PARKWAY | VICTORIA

PARKWAY | STUDIES IN RESPONSE TO COV FEEDBACK

JULY 10, 2020

ITEM #2 - WINDOW MULLIONS - SUMMARY

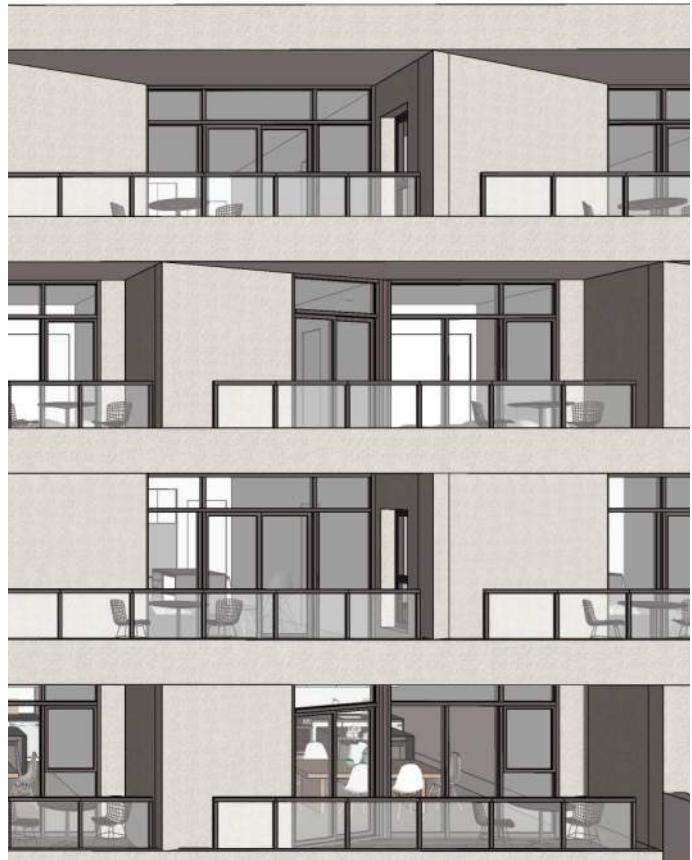
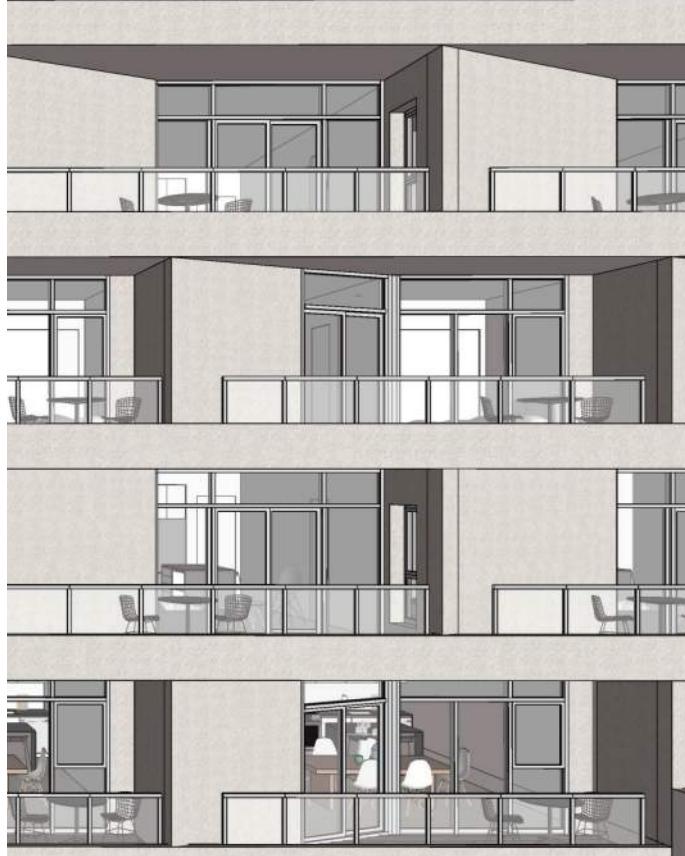
2	6-Storey Volume	Window transoms	A transom has been added to make the project financially and technically feasible. Windows maintain the same dimensions as the DP submission. % of Glazing remains unchanged and consistent with rezoning daylight studies.	Window transoms look busy on 6-storey volume – vertical lines read too strong MGA to explore options: lighter colour or thinner mullions.	Study completed. Vertical mullions are removed from the 3-panel window module. Due to manufacturing constraints, we have been unable to remove these from the 4-panel window units. Further removal of the mullions will have a significant cost impact, since a frame upgrade would be required due to water penetration resistance requirements. The final design solution resulted in a more quiet design without reducing the amount of glazing -and hence daylight penetration- in the units.	Yes
3	6-Storey Volume	North Facade	Level 6 parti revised. Sawtooth layout replaced with solid condition consistent with South facade overall design. An additional unit is gained	No issues. MGA to confirm FSR	FSR below maximum allowed, as reflected on CALUC submission. Calcs will be included in Rezoning Re-submission package	N/A

VERTICAL MULLIONS MAKE THE FAÇADE LOOK
BUSY

NOTE:
MANUFACTURER LIMITATIONS APPLY.
- 12'-0" SINGLE GLAZING EXCEEDS MAX. DIM.
- 9'-0" SINGLE GLAZING ACHIEVABLE
* Further removal of the mullions will have a significant cost impact, since a frame upgrade would be required due to water penetration resistance requirements.

UNIFIED MULLION COLOR AND TYPE
REDUCED NUMBER OF VERTICAL MULLIONS
BALANCE BETWEEN DESIGN INTENT AND BUD-
GET CONSTRAINTS

WINDOW MULLIONS
VERTICAL MULLIONS REMOVED FROM THE
3-PANEL WINDOW MODULE

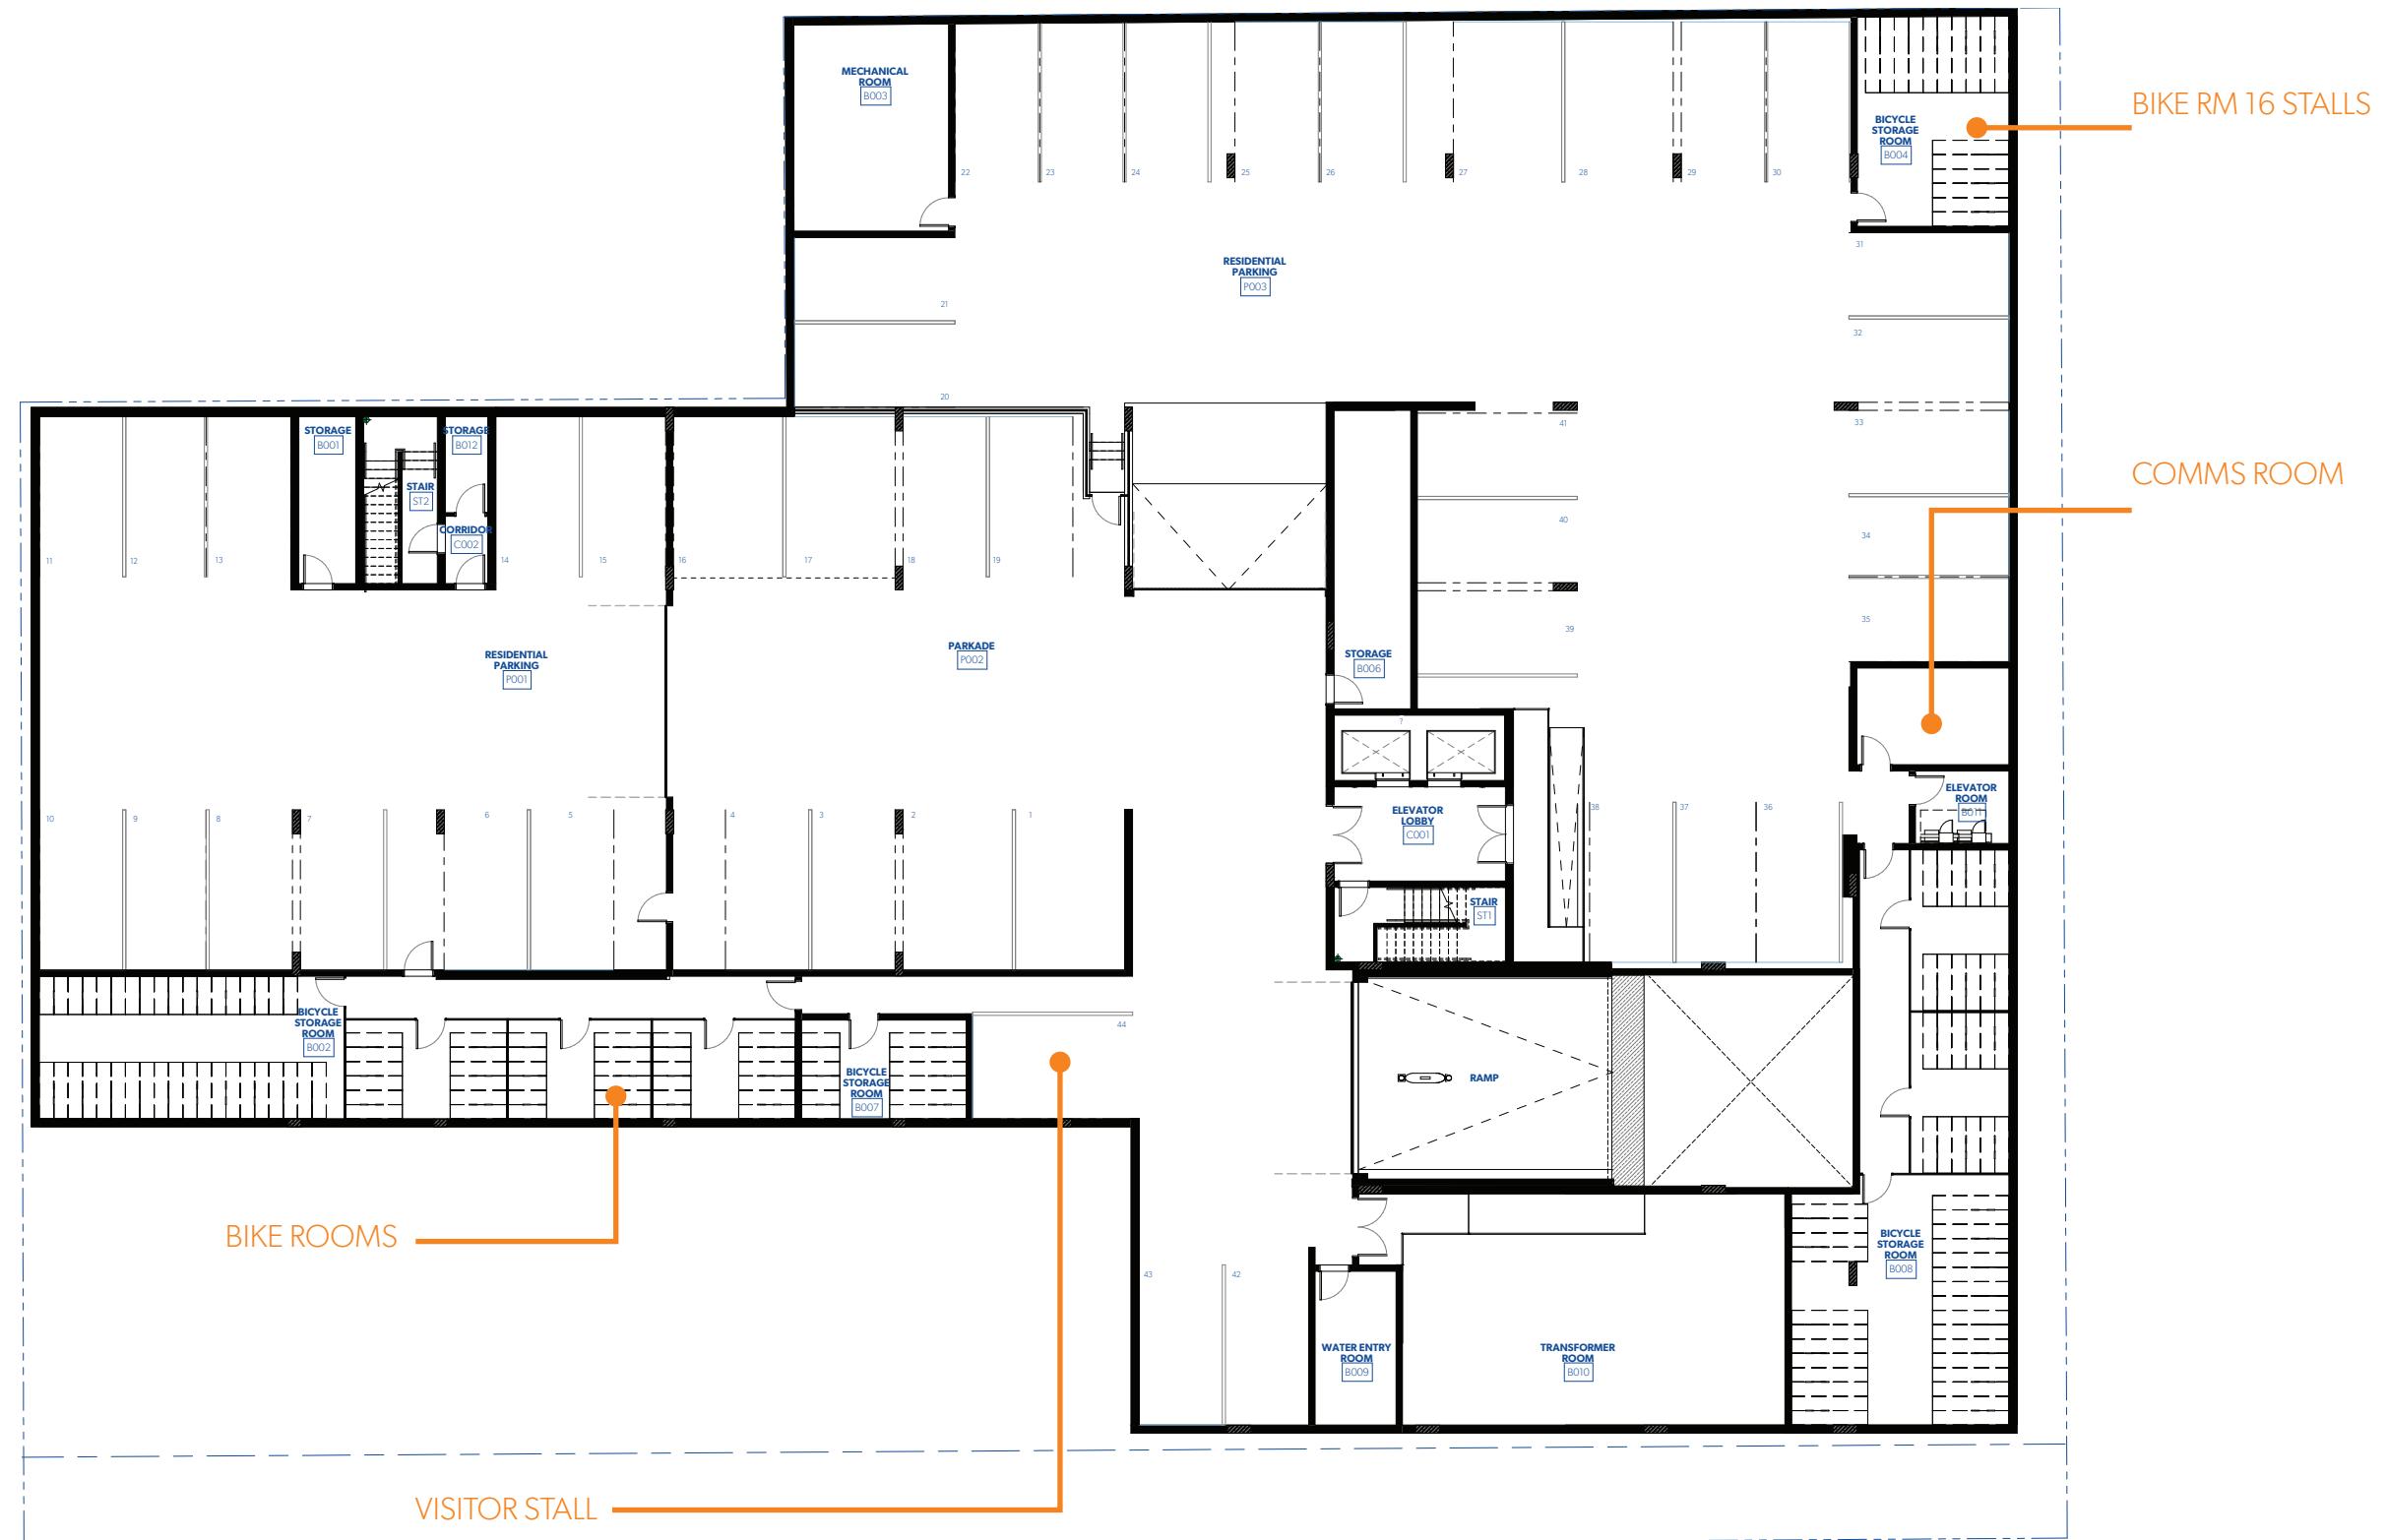
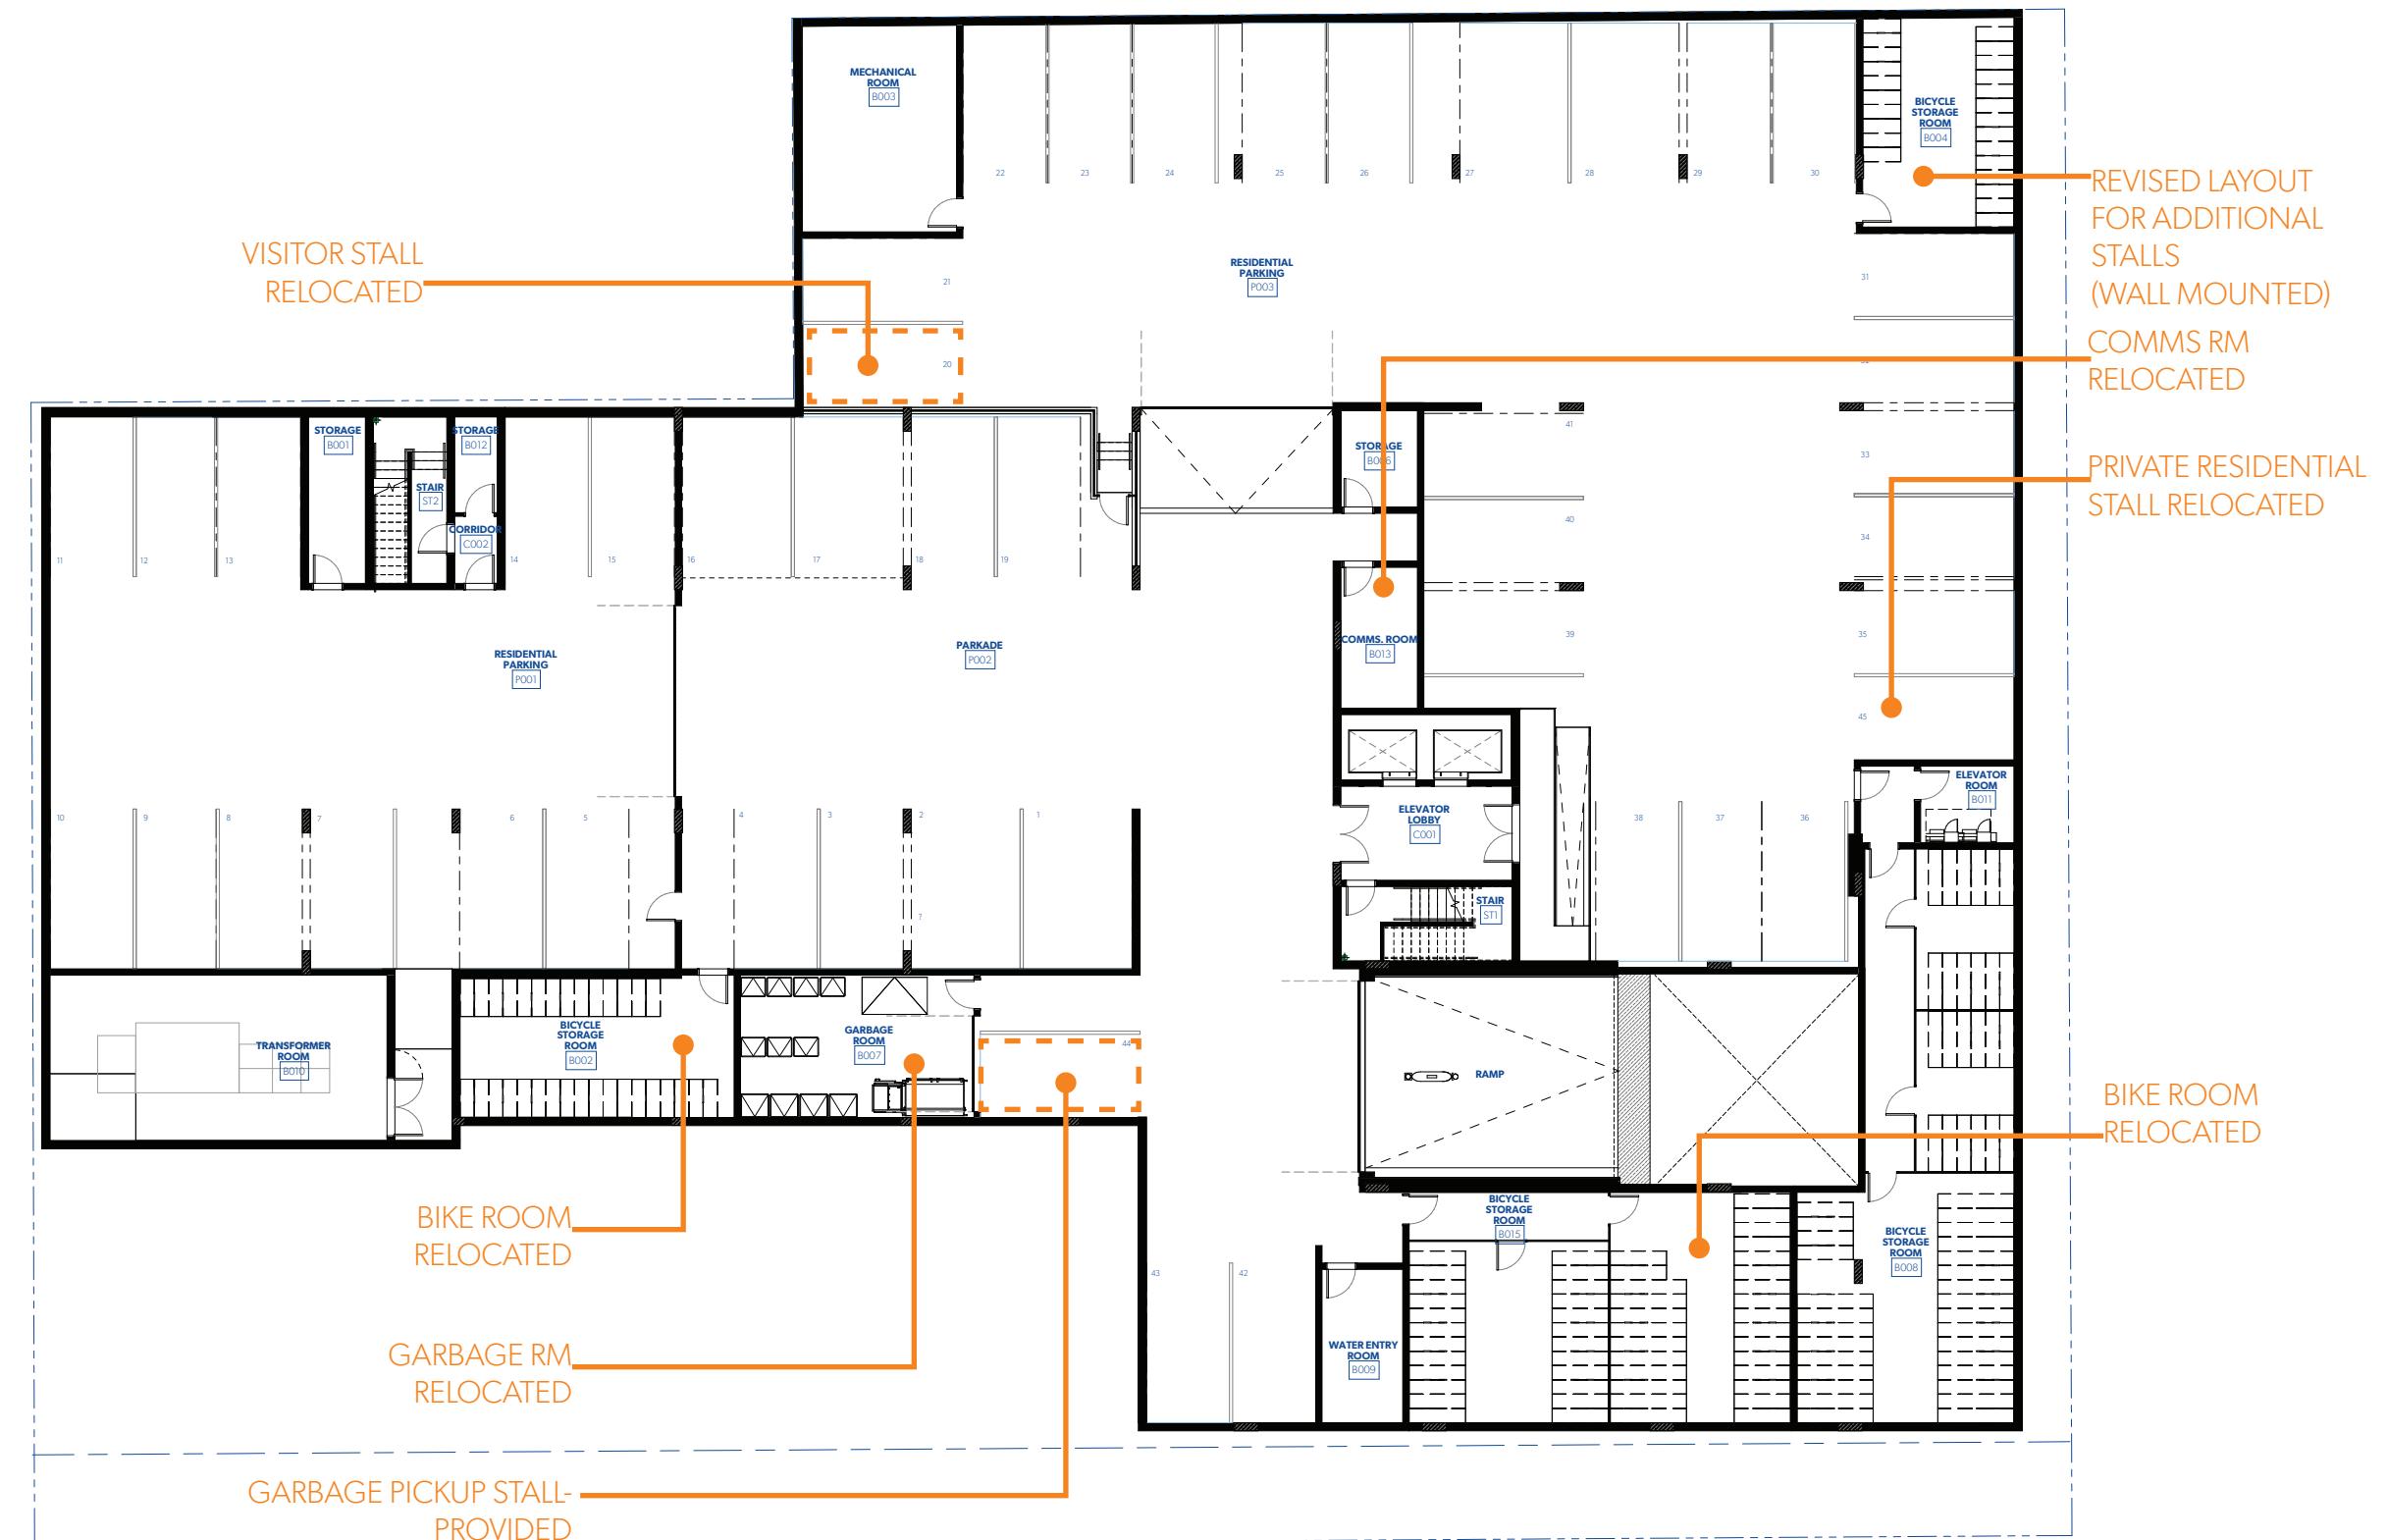
4	Level 0	Garbage Room	Garbage Room is relocated to level 0.	COV concerns about garbage loading area overlapping with the fire exit and pedestrian passage COV suggest for MGA to show garbage staging area at grade.	A dedicated garbage pickup stall has been provided at basement level. A leveled Garbage Staging area has been added to level 1, adjacent to the loading bay. Exiting stairs relocated to avoid overlap between garbage staging and fire-exiting requirements.	Yes
5	Level 0	Parking Count	Relocation of a transformer room to Pandora Ave required for proximity to BC Hydro HV lines. 1 additional private car stall is gained.	COV suggests for MGA to revise additional car stall to be a visitor stall instead of a private residential stall, to avoid a set back in the permitting process.	Private stall switched to visitor stall within the gated parking compound. The ownership will incorporate access to this visitor stall into the access control plan, for residential visitors.	Yes
